RE: Proposed 4 Lot Subdivision – Square 1 Building Associates
Tripp Hollow Road
Brooklyn, CT
Beecher Rd
CLA 6503

Attached are revised plans addressing engineering comments dated 9/5/20. Please note the following:

Sheet 4 of 8

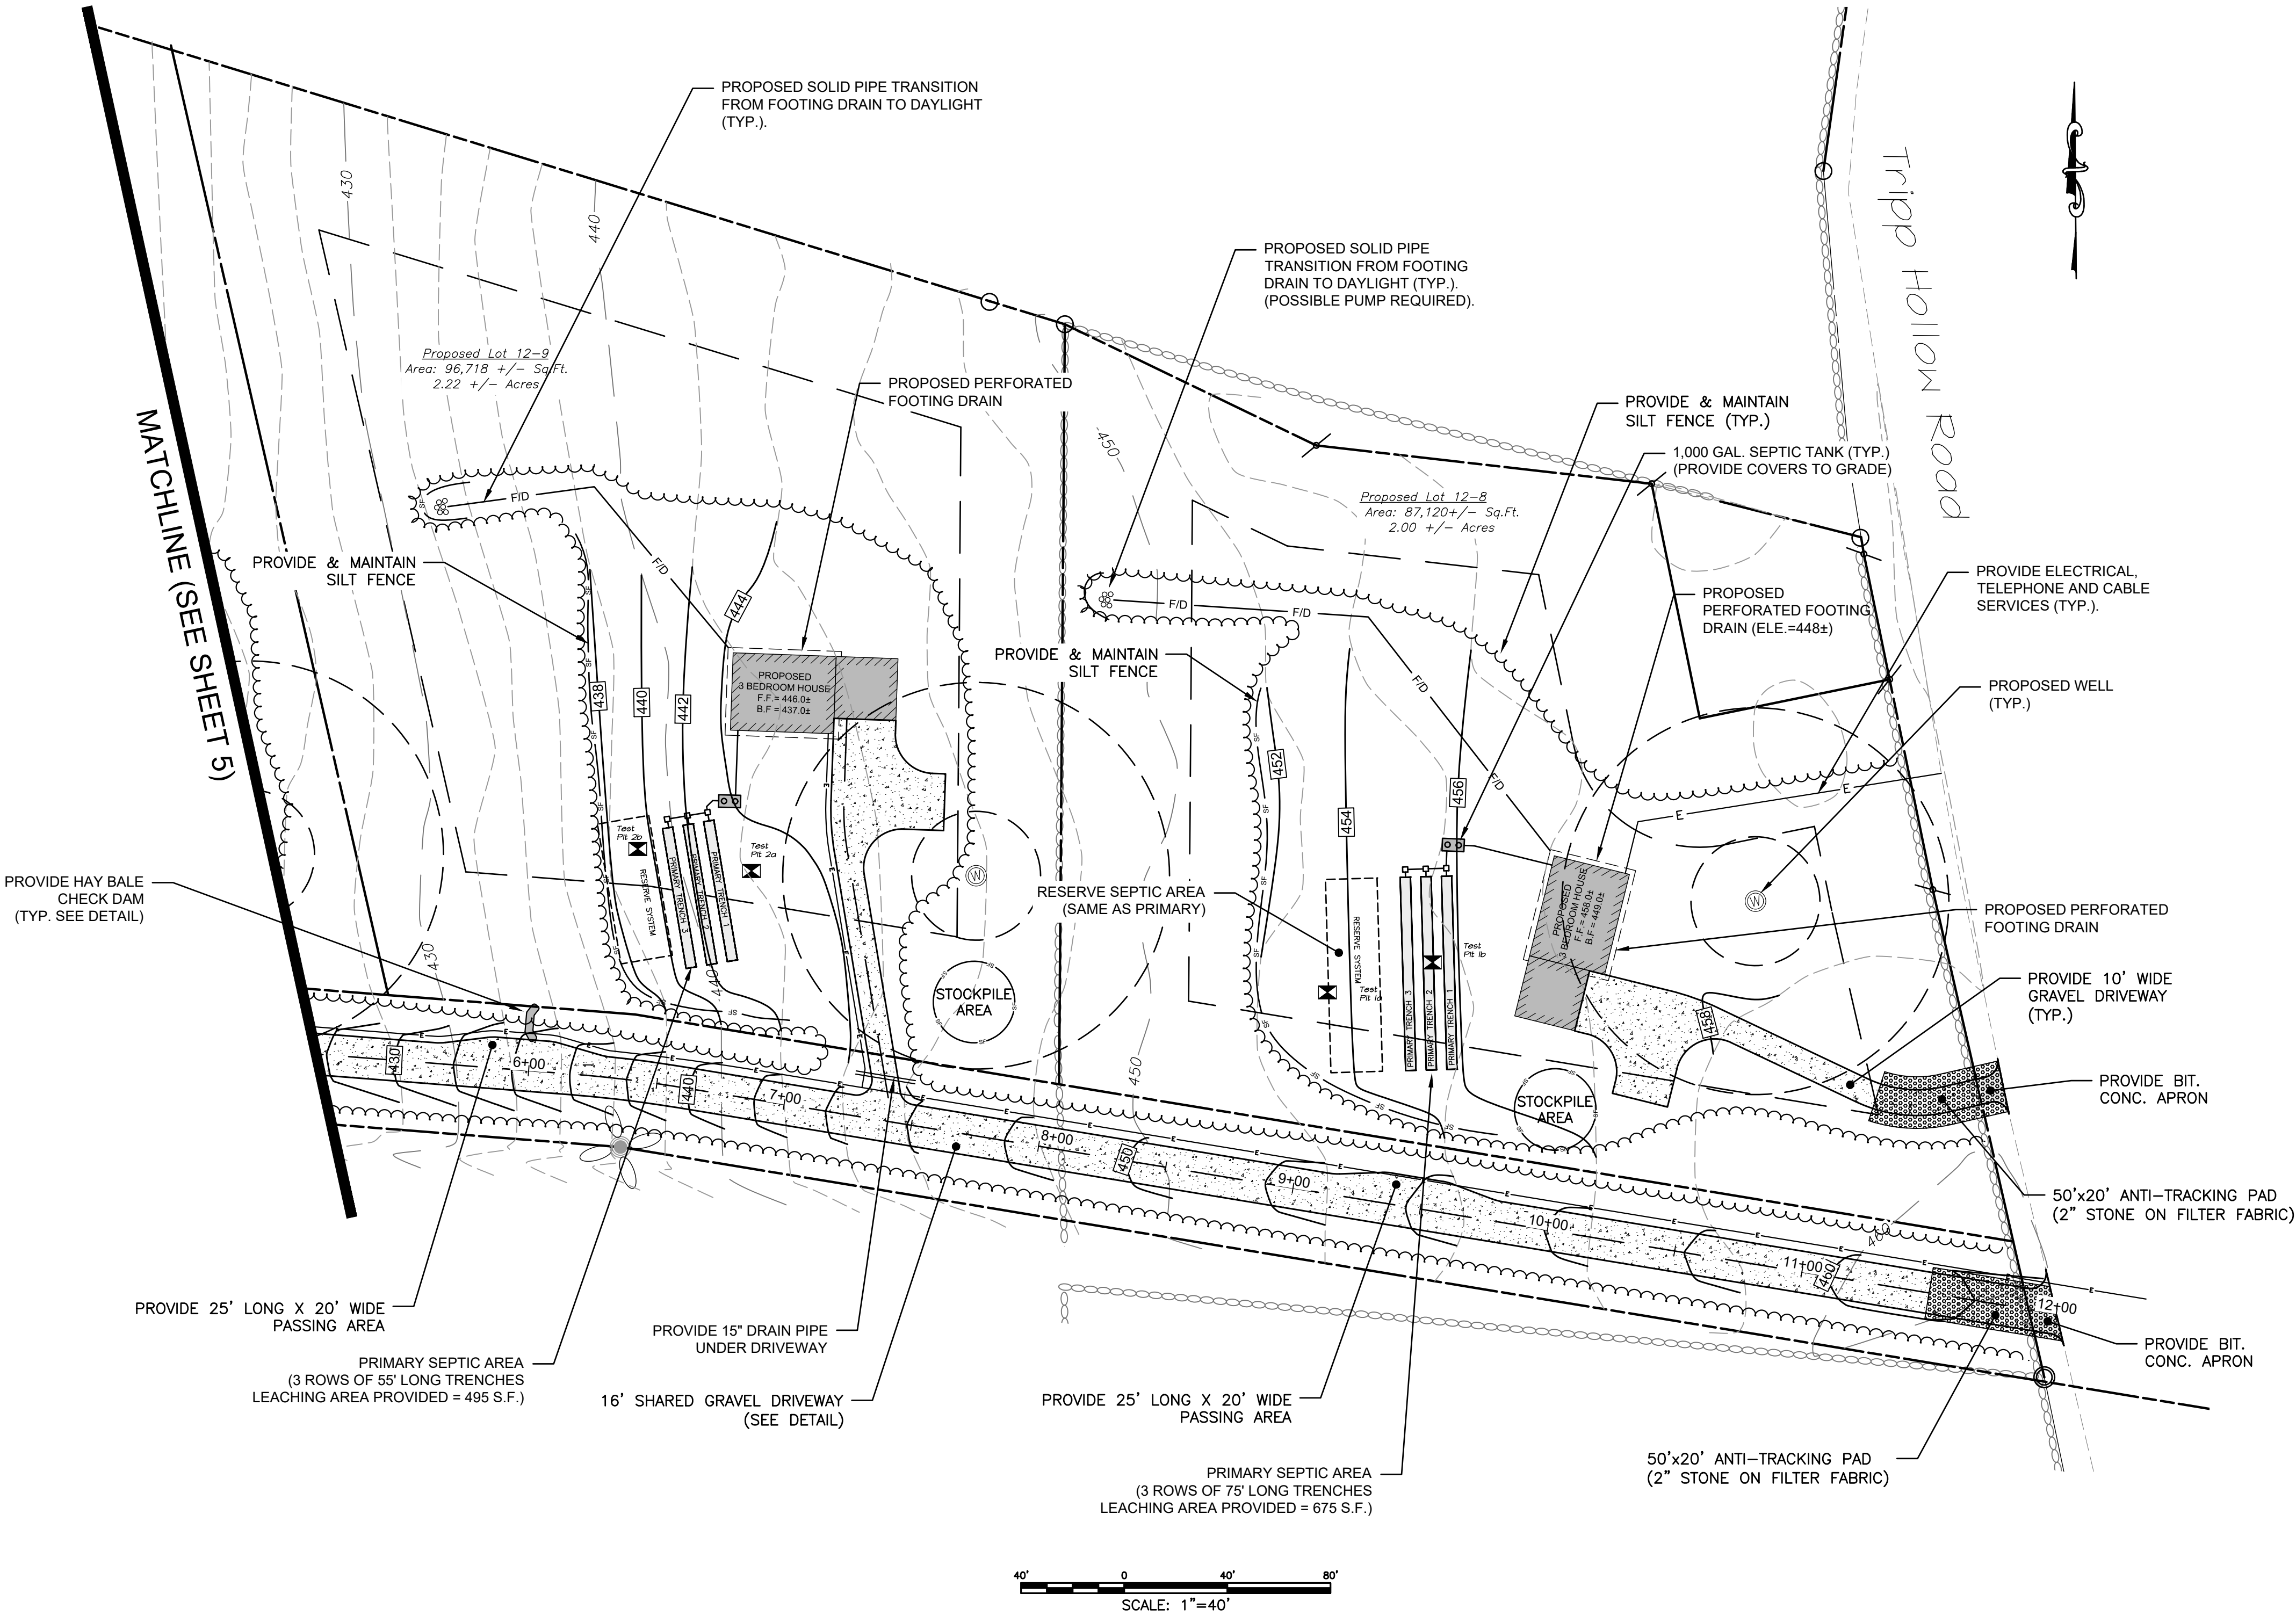
- 1) Hay Bale check dams have been added to plan in lieu of additional silt fence.
- 2) A pipe has been added under the driveway to lot 12-9.

Sheet 5 of 8

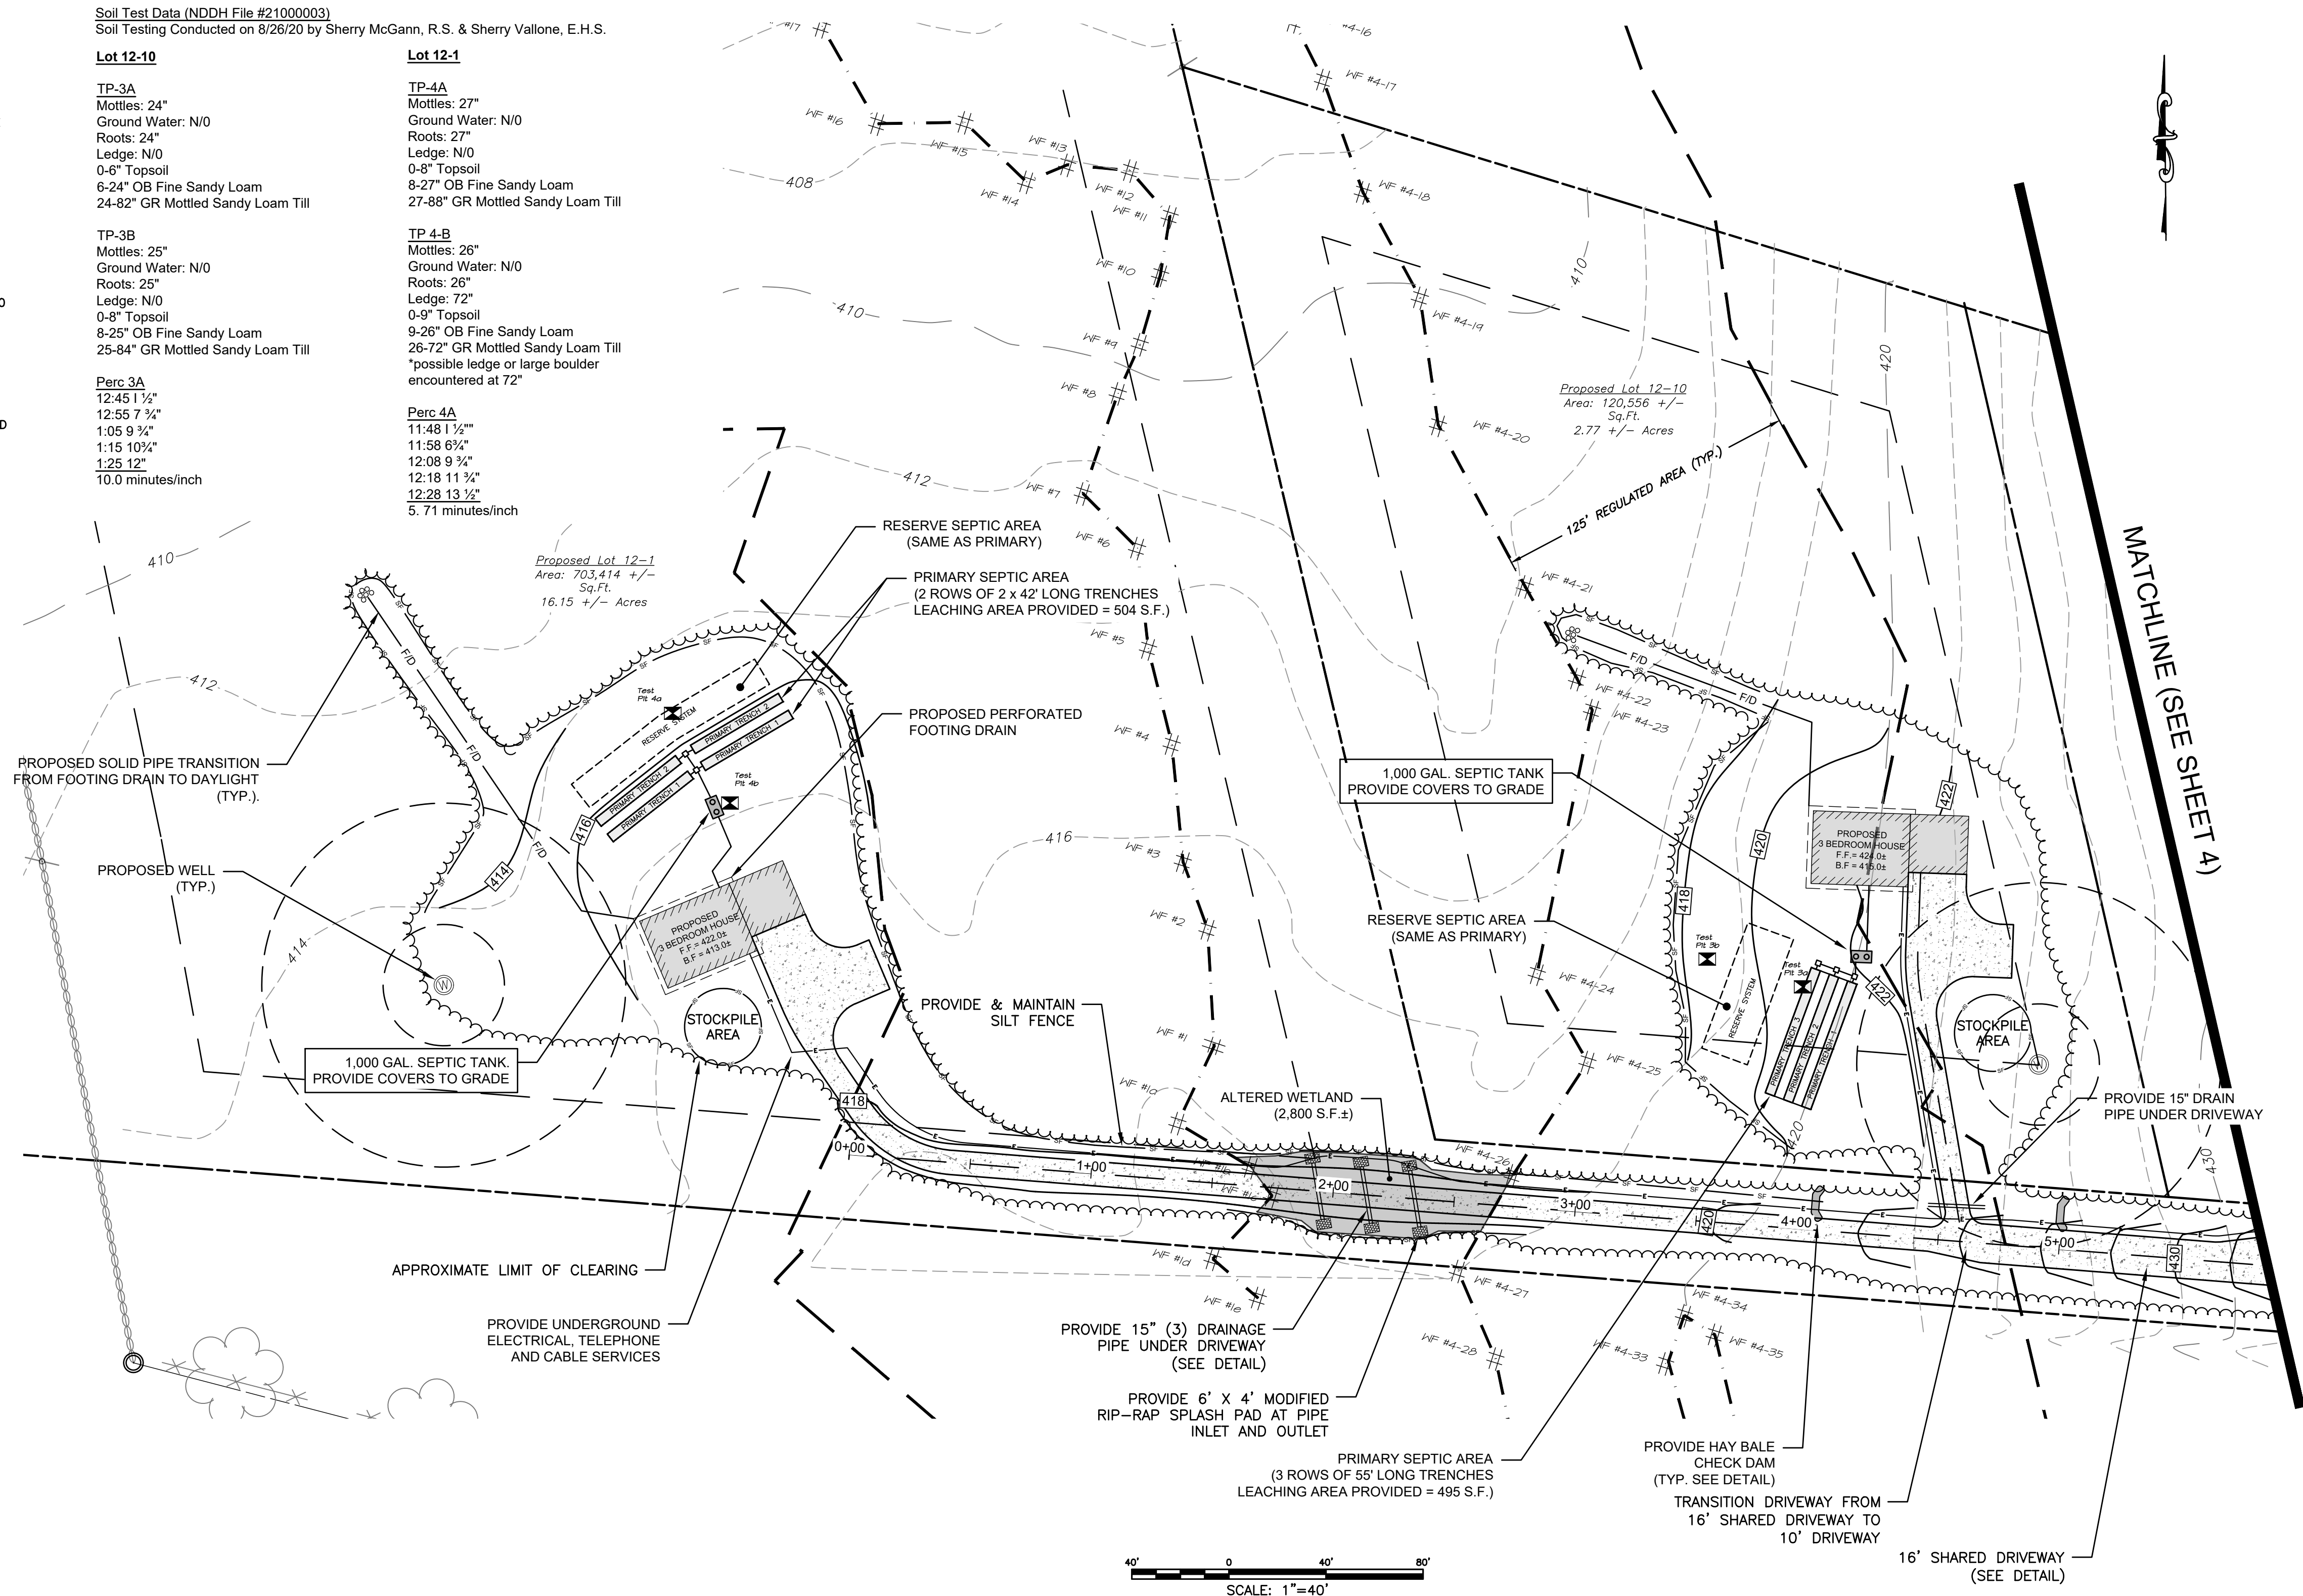
- 1) The area of wetland disturbed has been added to the plan.
- 2) Corrected

- 3) Hay bale check dams have been added to plan in lieu of additional silt fence. In addition, silt fence has been extended from wetland crossing to station 3+00 along shared driveway.

- 4) A pipe has been added under the driveway to lot 12-10.
- 5) Additional information has been added related to removing existing organic material and providing appropriate pipe bedding and backfill.

- 6) Per our Soil Scientist, unlike a larger culvert crossing (box culverts or 5'-6' diameter pipes) on a heavily traveled road, the increased height (due to the proposed 15" pipe) of a single driveway will not impede wildlife passage. Therefore, we feel gravel pipe bottoms are unnecessary and would potentially be a future maintenance concern with pipes of this size.

- 7) There was no evidence of channelized drainage flow near the crossing. In addition, multiple pipes and porous backfill material are proposed to spread out the flow. Multiple pipe crossings were a request of the Commission after the wetland walk. Therefore, we feel the need for flared end sections is unnecessary.

- 8) This comment is no longer applicable due to the redesign of the crossing.
- 9) Underground utilities have been relocated around pipe crossings.
